Subject: Submission of Review Note on Layout Drawing of Monitoring for Flushing Tunnel and DS Gate Operating House Access Tunnel of Desander Basin

UPPER TRISHULI-1 HEP (216MW)

REVIEW NOTE

Contractor	**Doosan Heavy Industries & Construction Co., Ltd.**		
Title of the Document	Layout Drawing of Monitoring for DS Gate Operating House Access Tunnel of Desander Basin		
Document No.	UT1-C-845-CVL-DG-70009	Revision	A
Date of Documents	09.01.2022	Received Date	11.01.2022
Transmittal Form No.	UT1-HEP-DHI-D-0115		
Previous Review Date/Status	N/A	Prev. Review Note No.	N/A
Review Note No.	**RN-0046**	**Present Review Date**	**11.01.2022**
		Present Review Status	**AC**

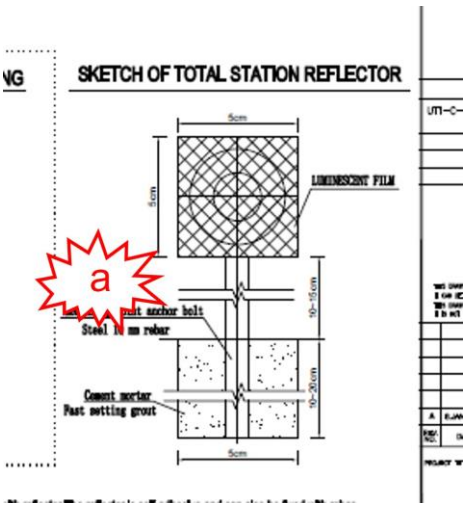
a) Distance between rock surface and target should be "max. 30 mm" and not "10 cm – 15 cm".
